ADDENDUM NO. 2

HELENA FIRE STATION #3

PROJECT: Helena Fire Station #3
Helena, Montana

ARCHITECT: DOWLING Architects
734 North Last Chance Gulch
Helena, MT 59601
406-457-5470

FIRST FLOOR
PLAN - WALL
TAG PLAN

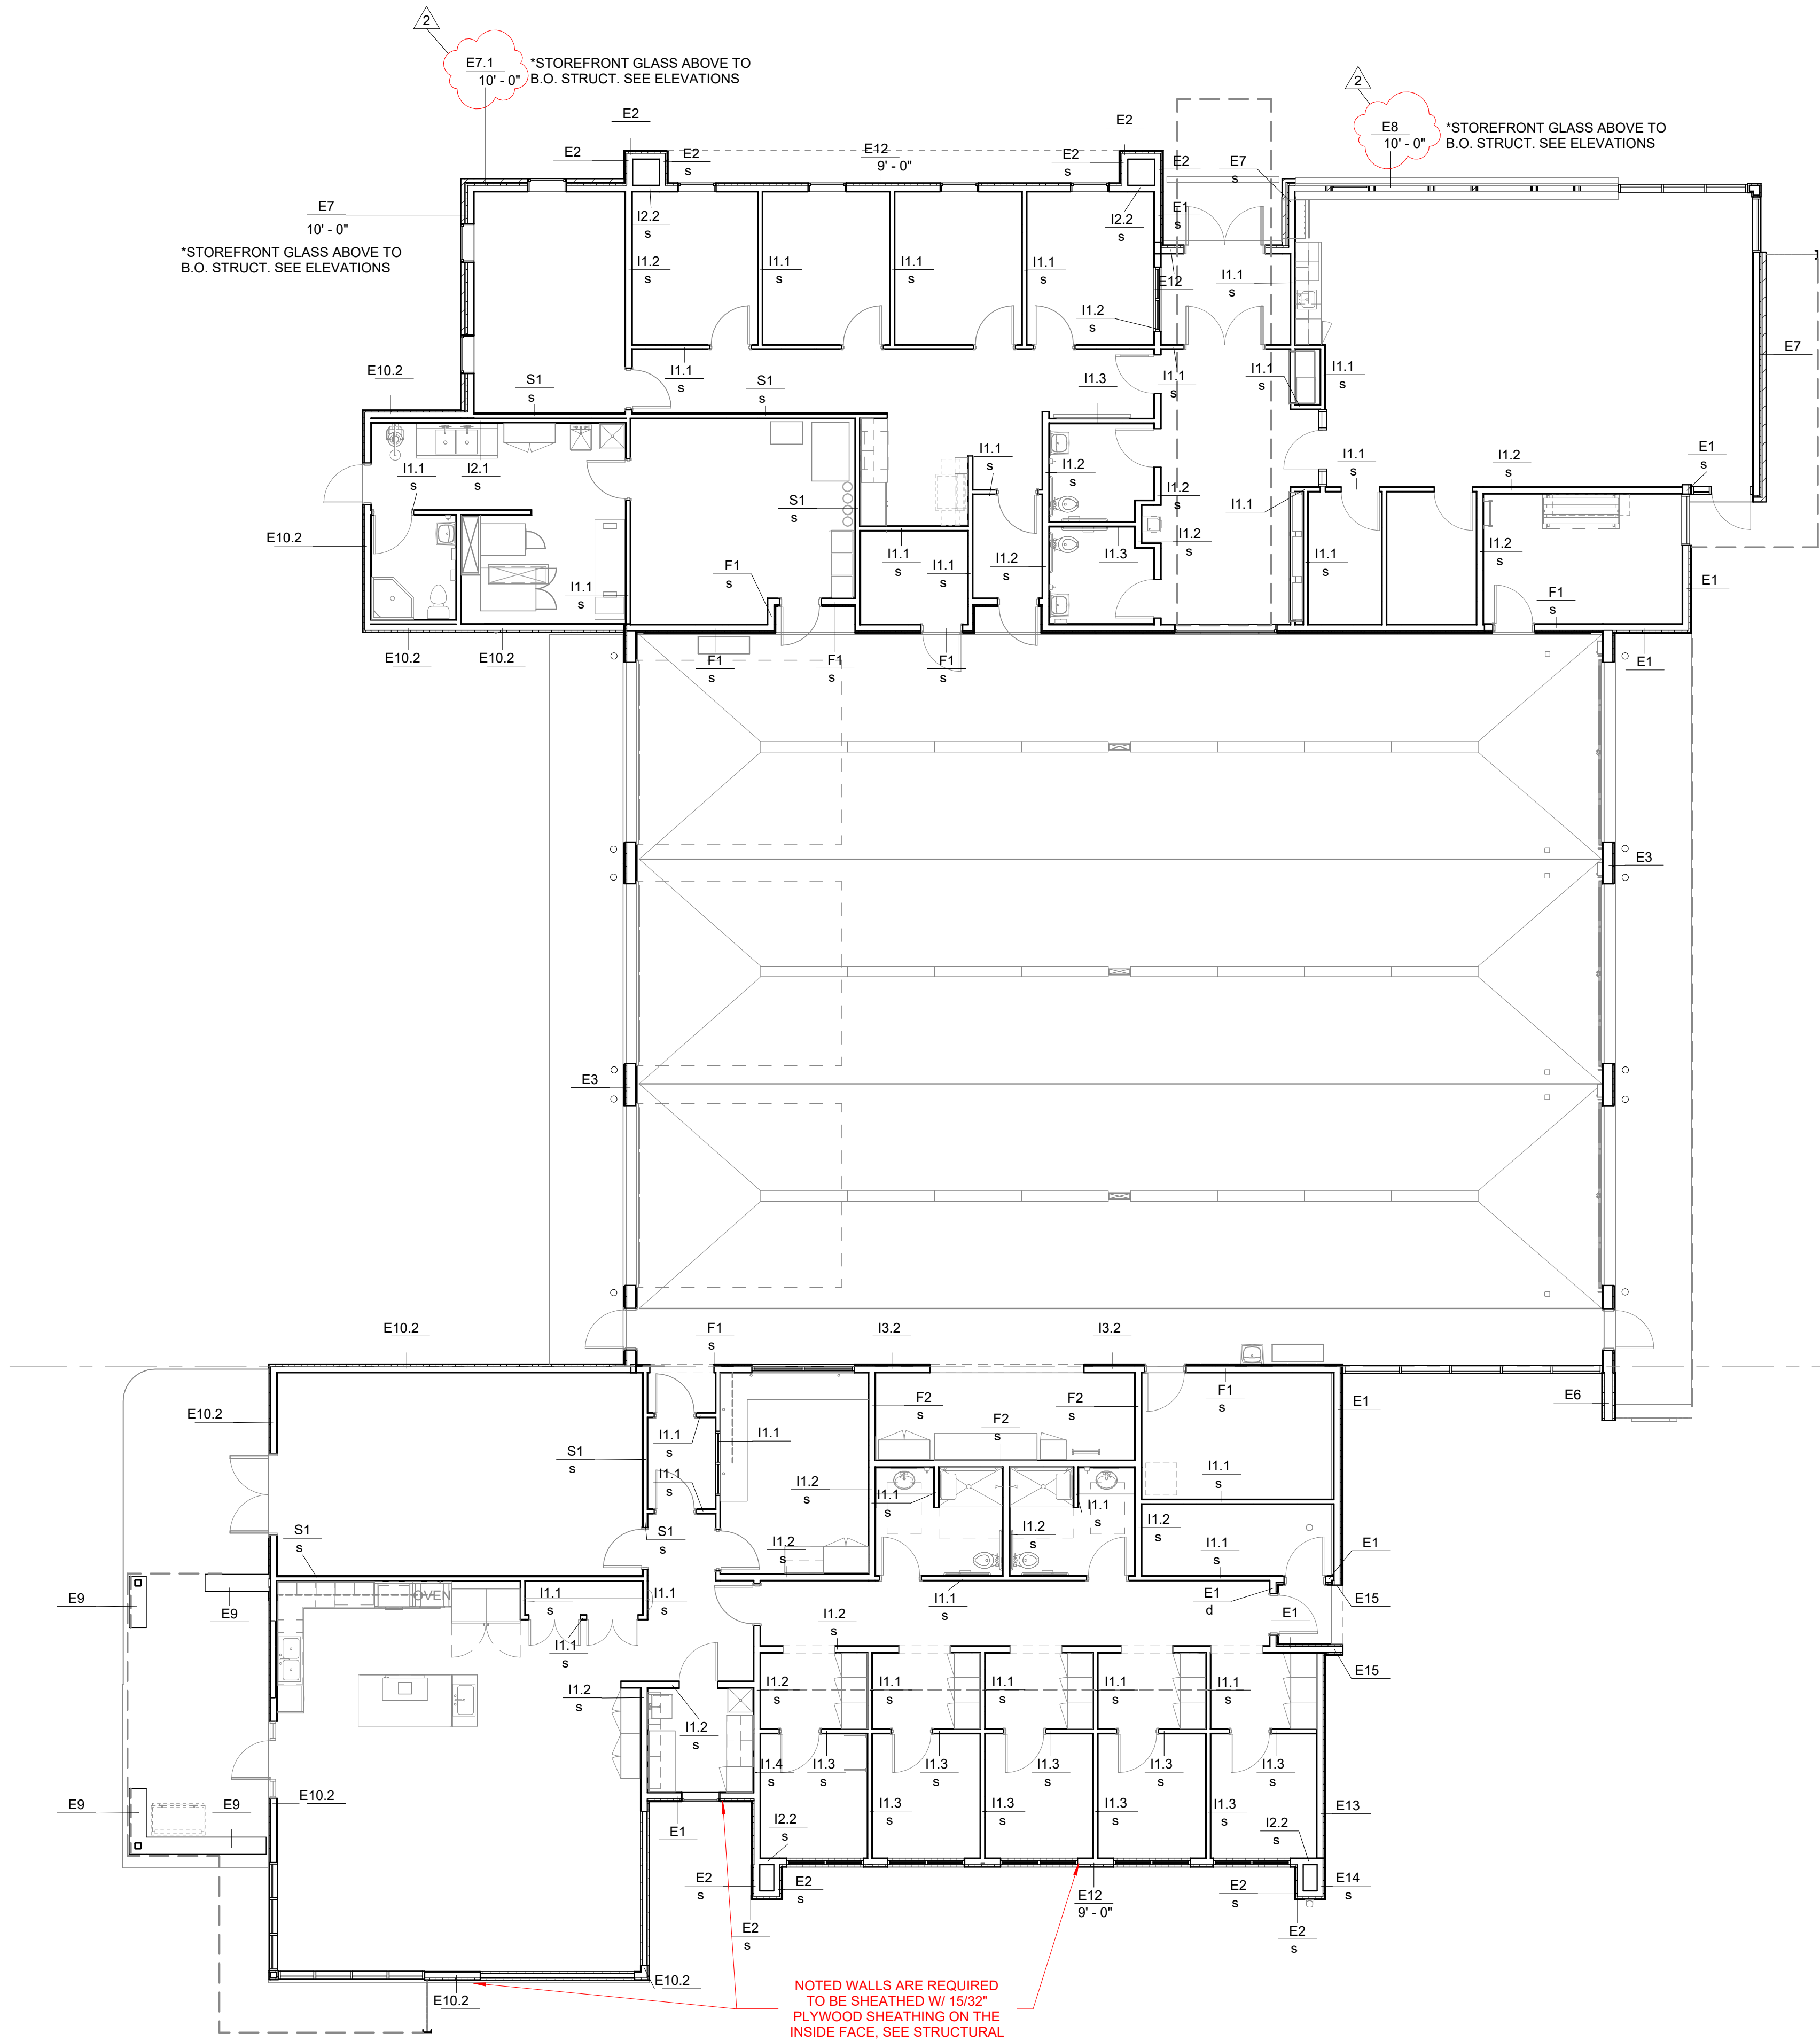
- **Sheet A1-2 First Floor Plan Wall Tag Plan** – Shows the specific walls affected by the updates to wall assemblies E7 & E8
- **Sheet A7-3 Interior Elevations-** Revised notes to accurately reflect locations of countertop type (P-Lam or Solid Surface) & Revised note further specifying FRP Product

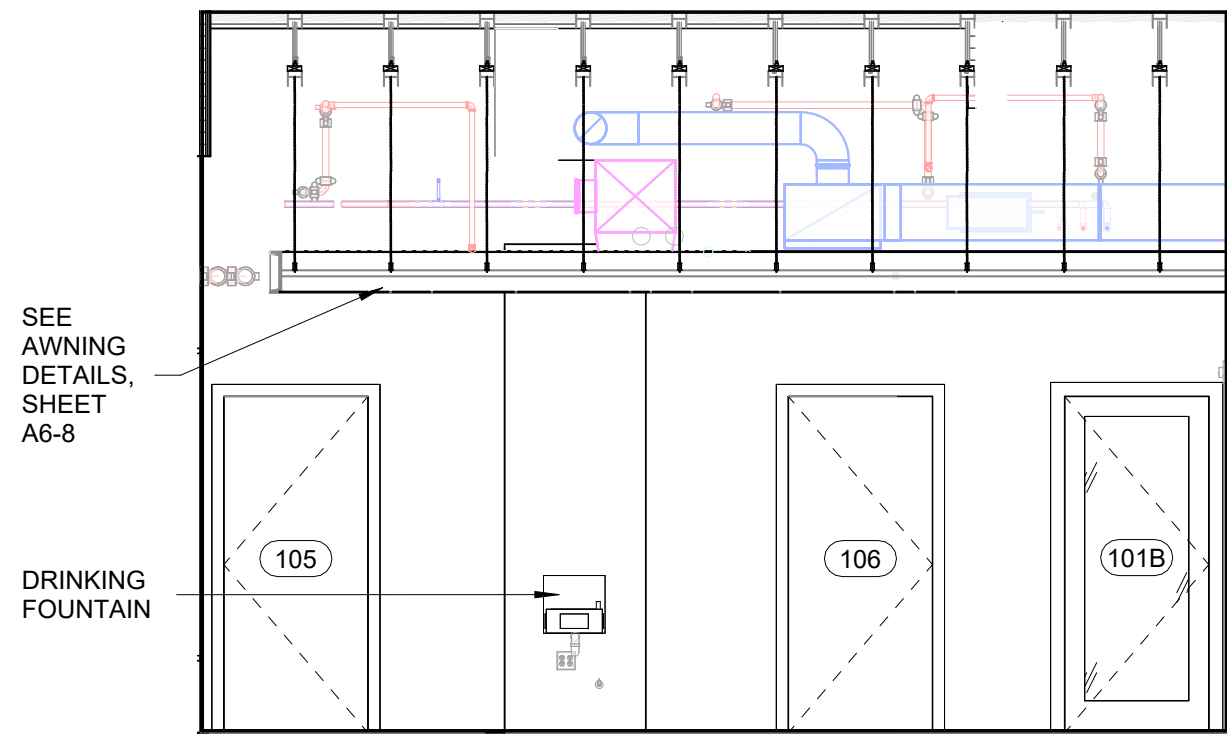
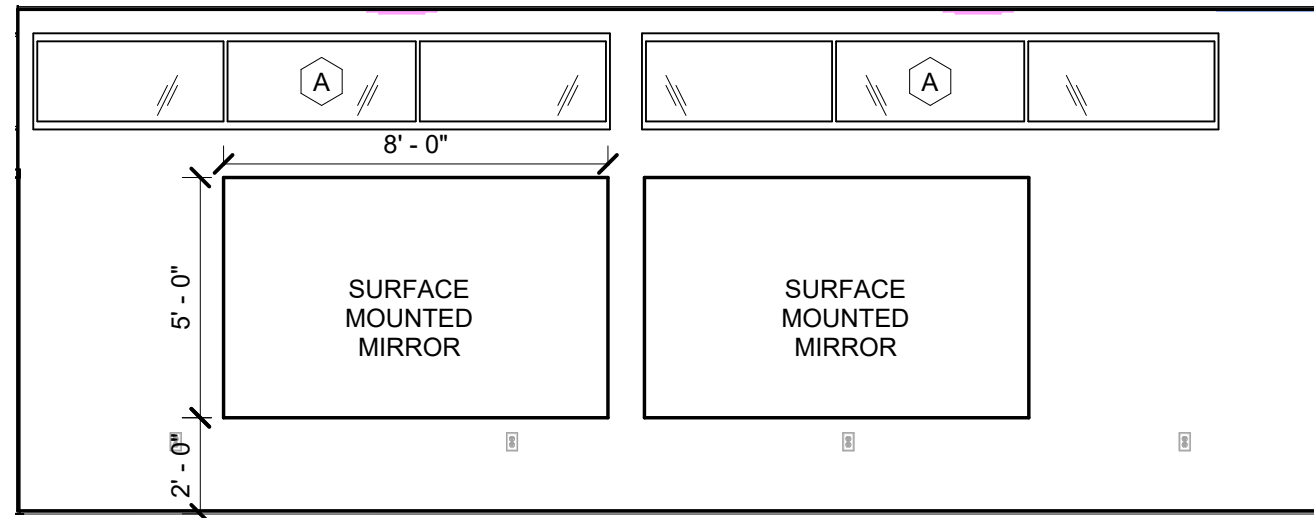
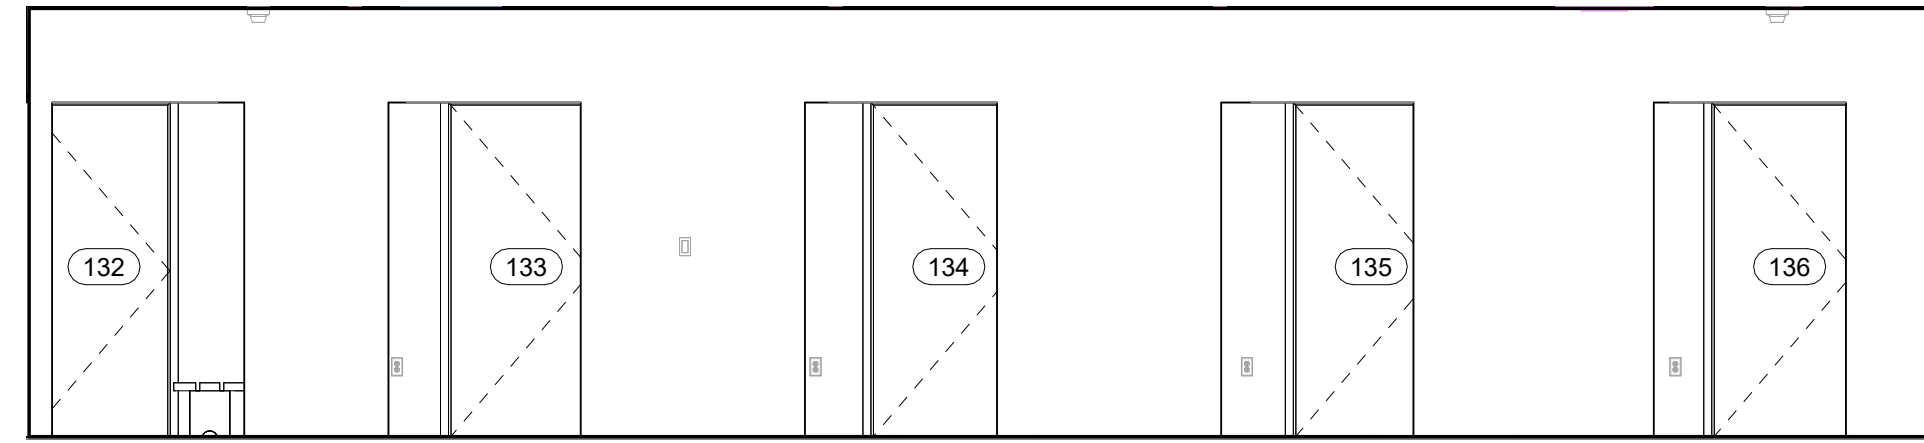
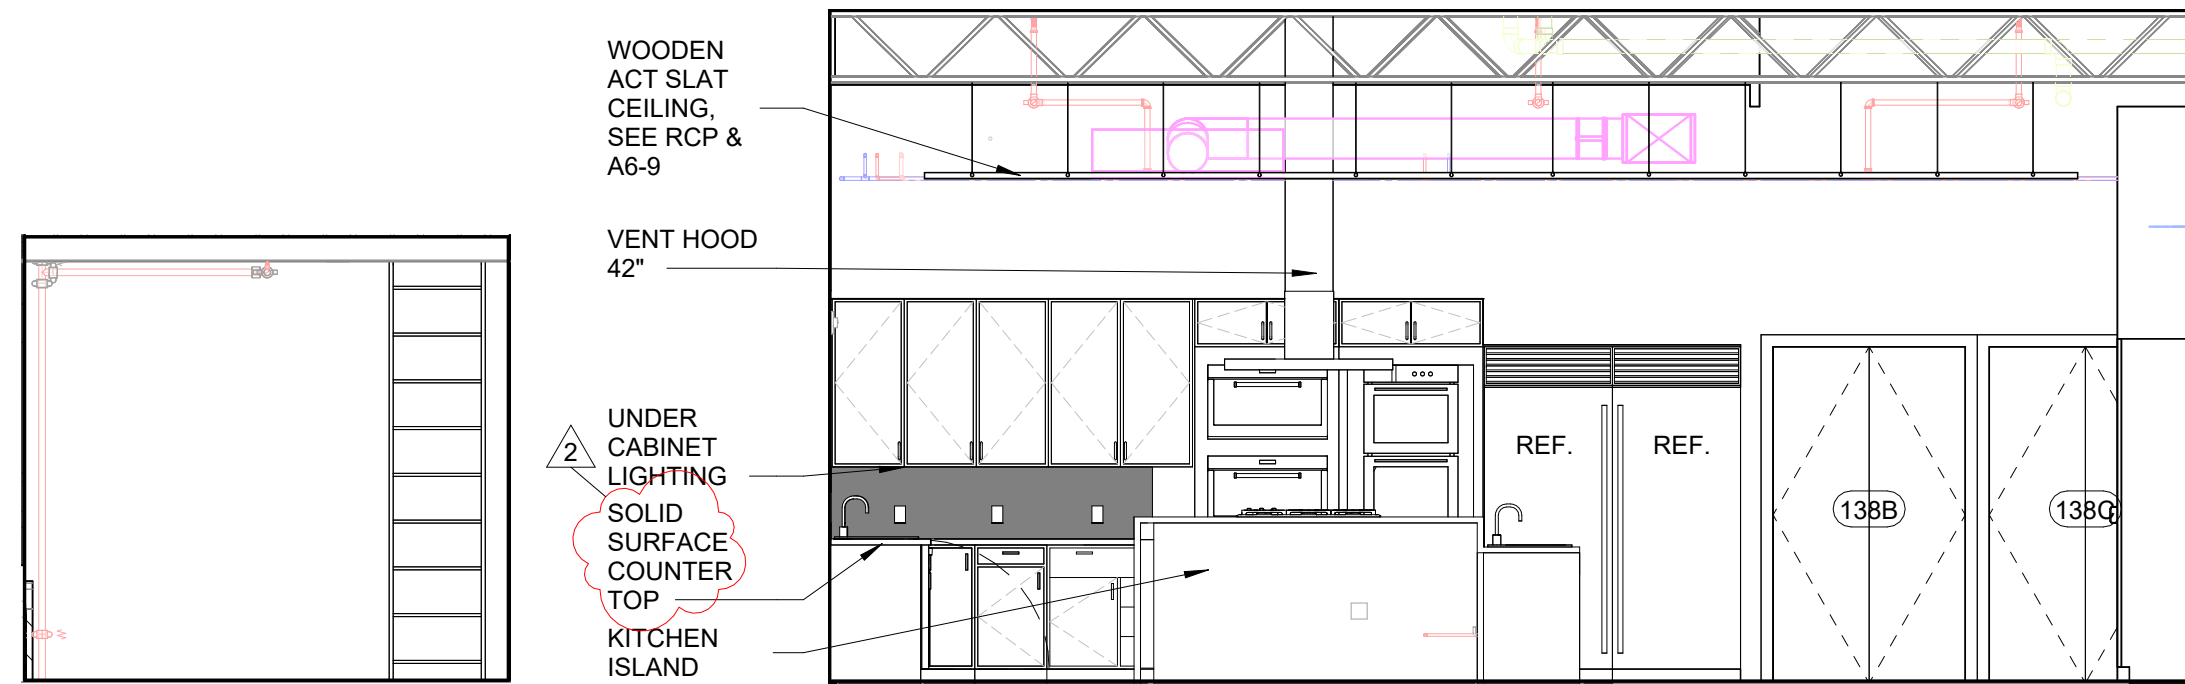
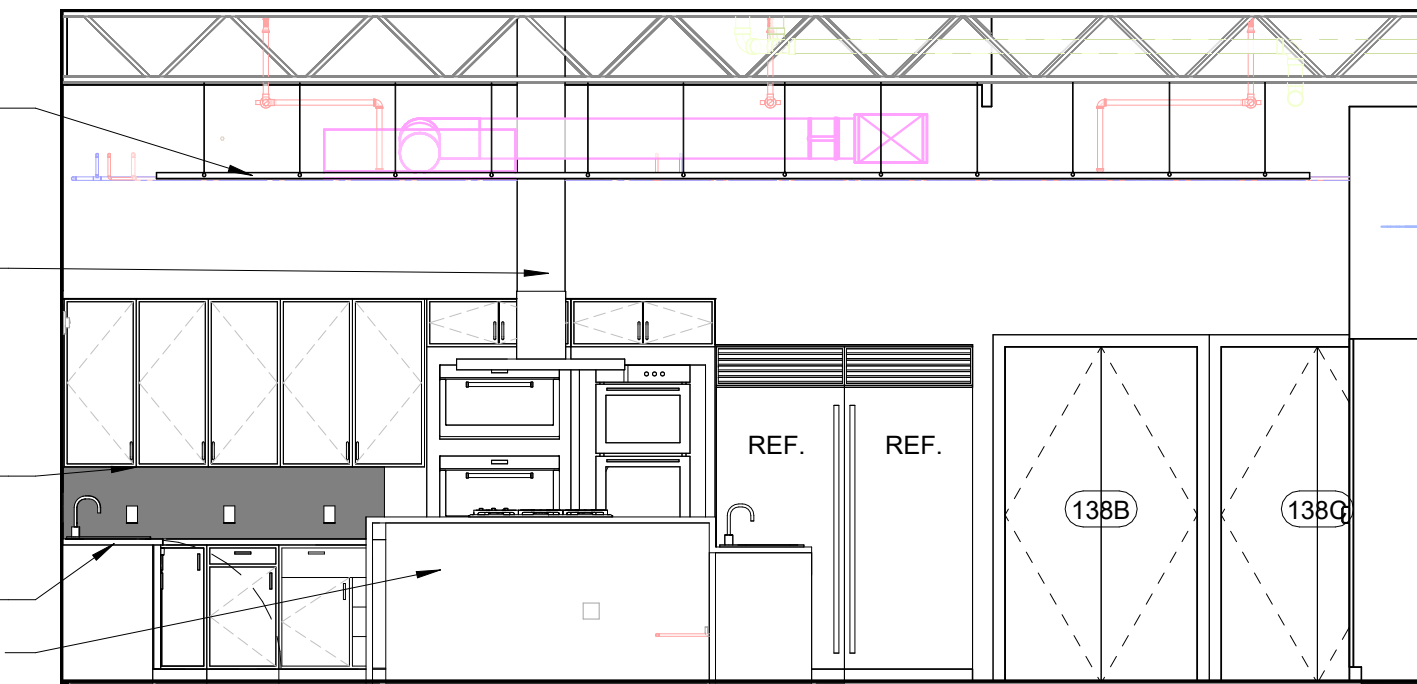
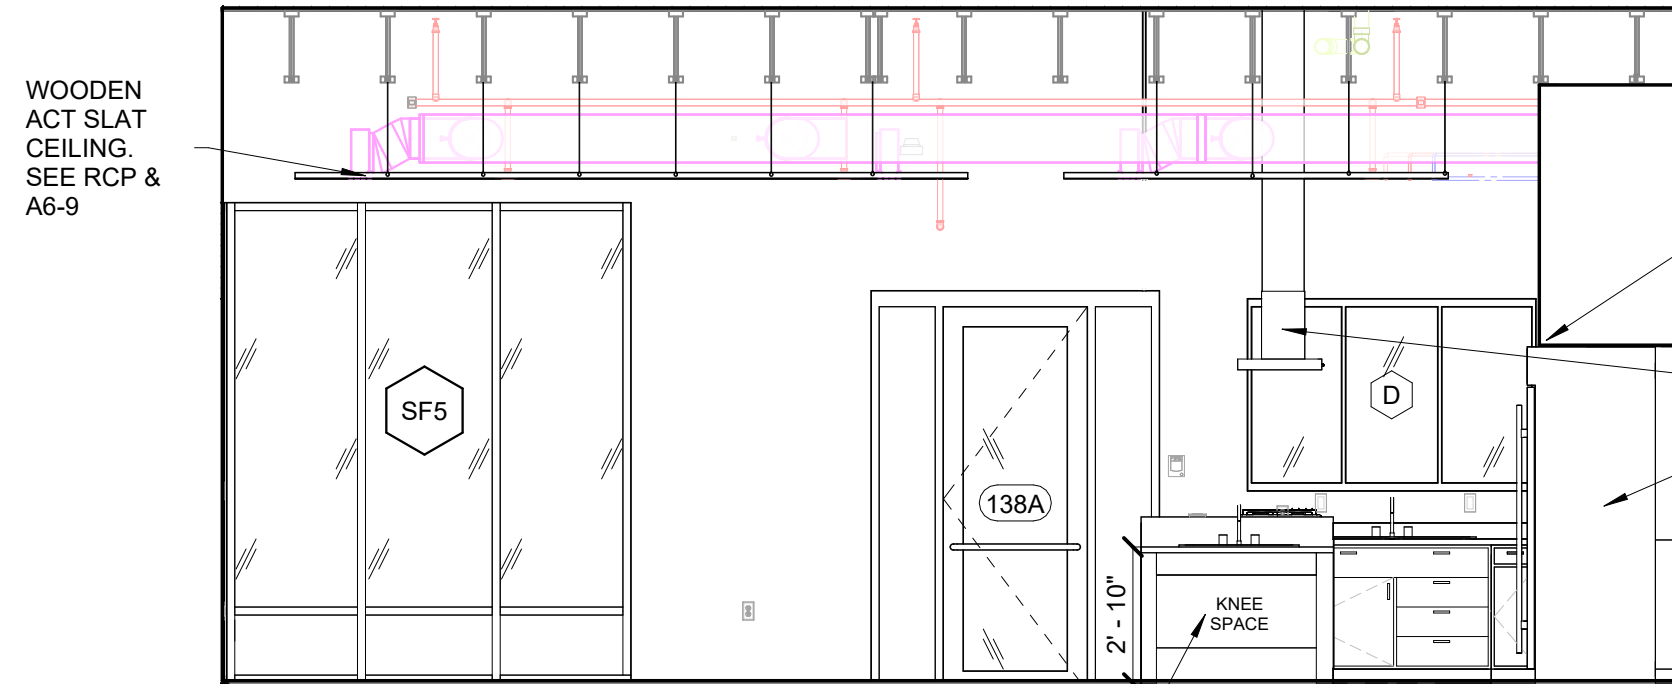
- **Sheet A7-4 Interior Elevations** - Revised notes to accurately reflect locations of countertop type (P-Lam or Solid Surface)
- **Sheet A7-5 Interior Elevations** - Revised notes to accurately reflect locations of countertop type (P-Lam or Solid Surface) & Revised note further specifying FRP Product

- EXPOSED SINK DRAINS TO BE COVERED BY ADA PROTECTIVE BOOT.
 - COUNTER TOPS IN DAYROOM, BATHROOMS 124 & 125, AND CLASSROOM TO BE SOLID SURFACE. EVERYWHERE ELSE, COUNTERTOPS WILL BE P-LAM
